PUBLIC UTILITY DISTRICT NO. 1 OF CHELAN COUNTY

**ADDENDUM NO. 1
BID NO. 16-25
April Drive Water Main Replacement**

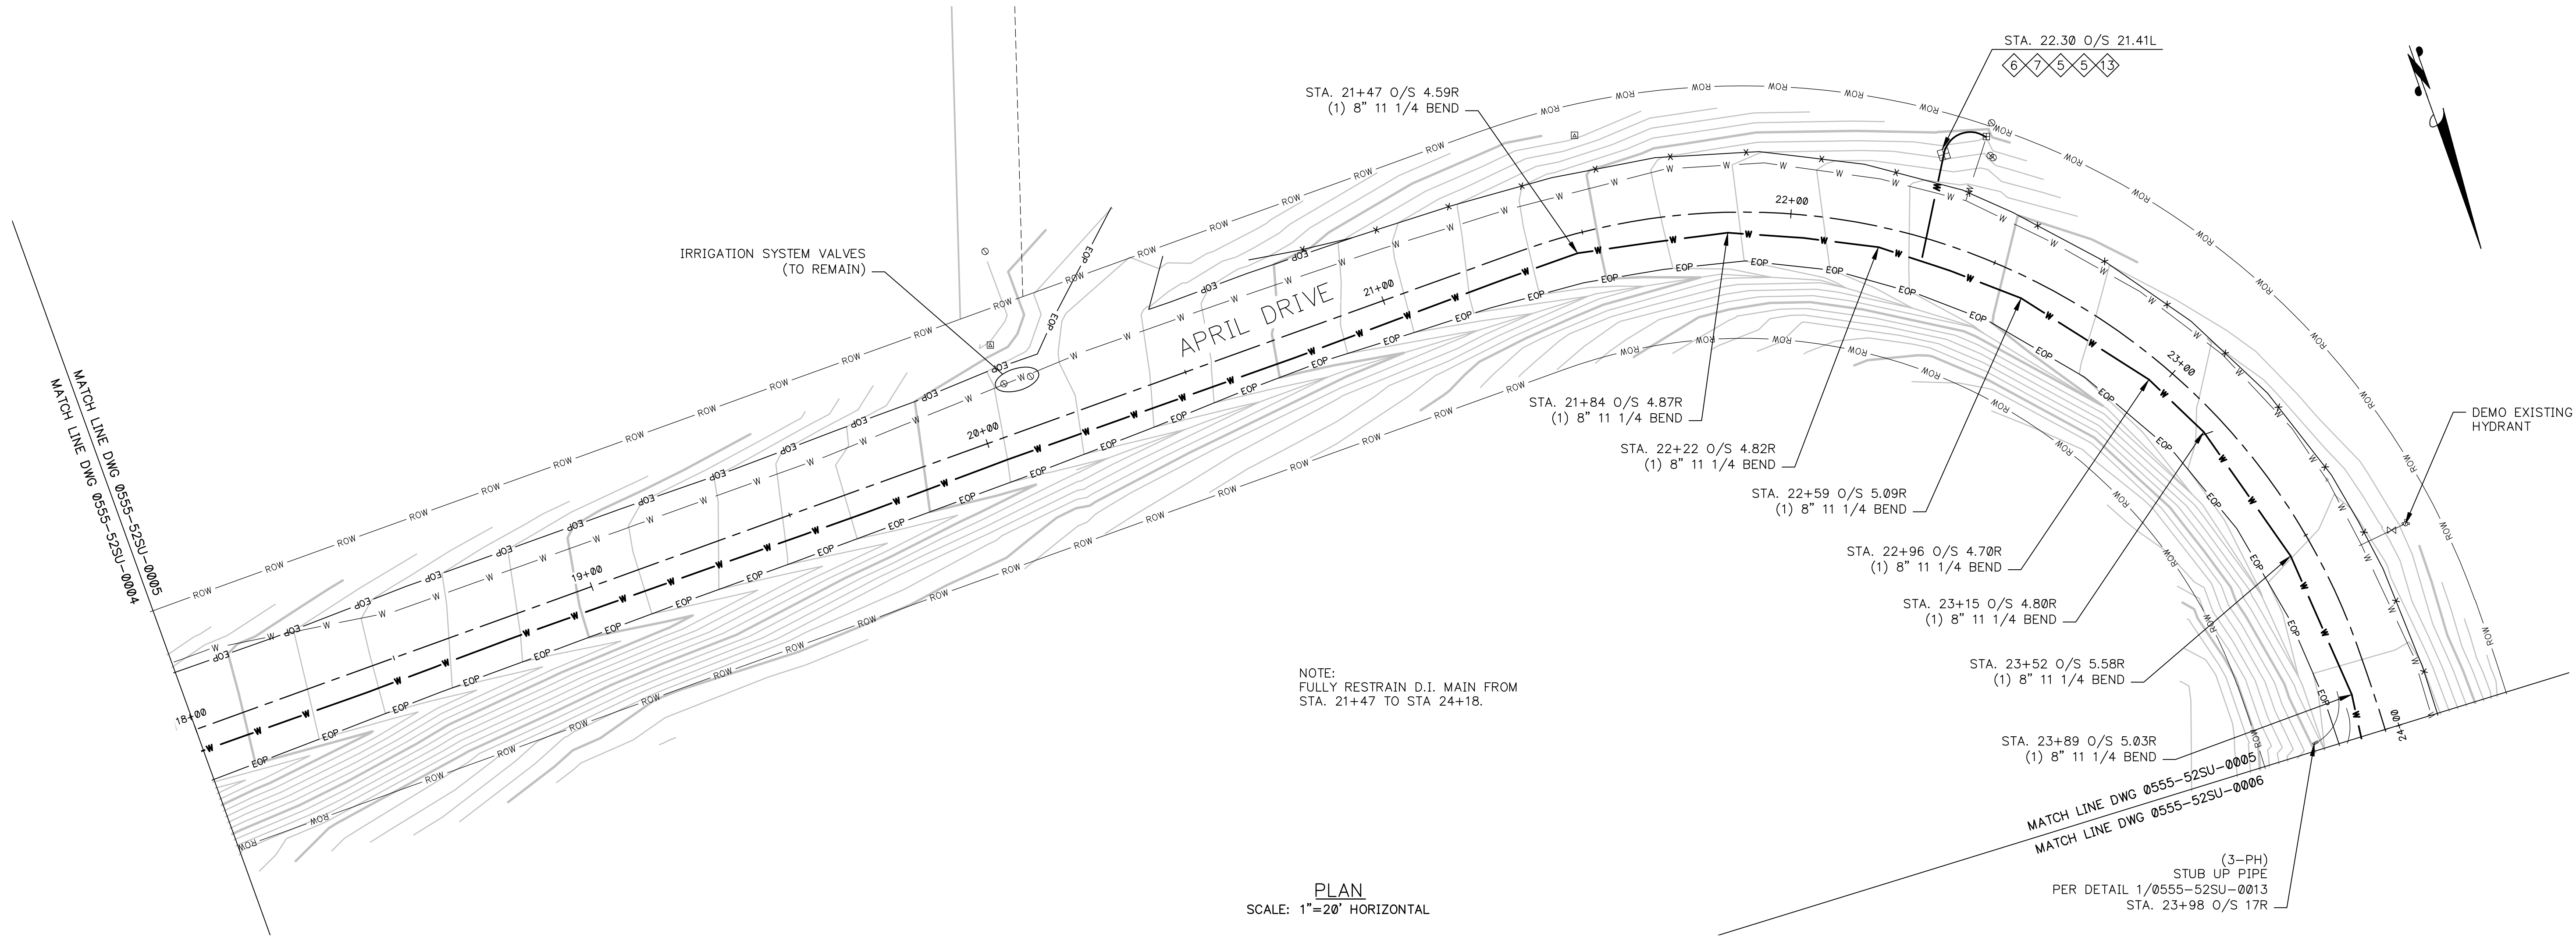
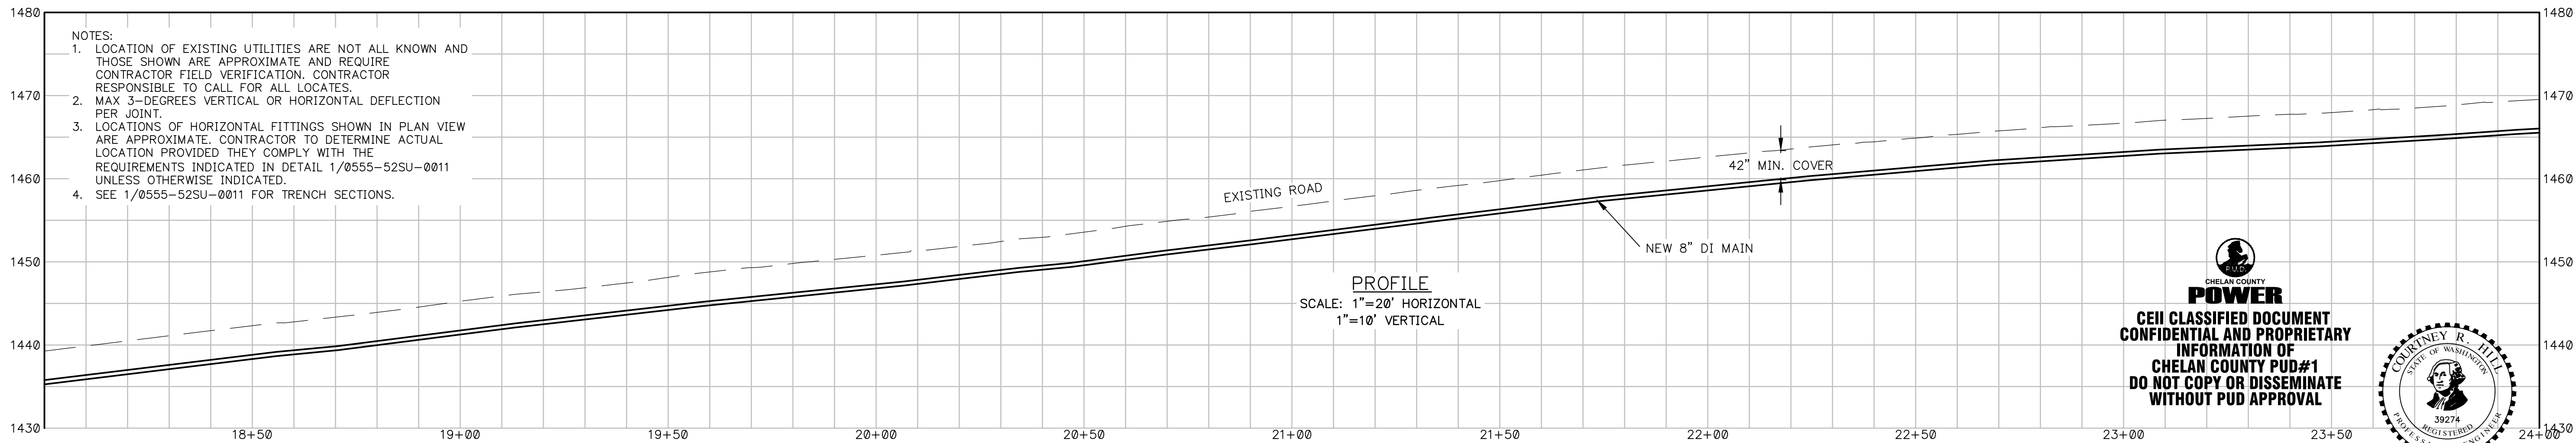
- A: Yes, in accordance with Detail 5 they should have restraint lengths of 39 feet each side of the bend.
9. Q: Are there any pipe restraint requirements in addition to those called for in Detail 5: Pipe Restraint Requirements on Sheet 14 in Exhibit T – Contract Drawings (DWG. 0555-52SU-0012)?

- A: Yes, additional restraint requirements are noted on sheets 6 and 7, Exhibit T – Contract Drawings (DWGs. 0555-52SU-0004 & 0555-52SU-0005). These notes call to full restrain the 8" D.I. main from sta. 12+04 to sta. 13+98 and from sta. 21+47 to sta. 24+18.
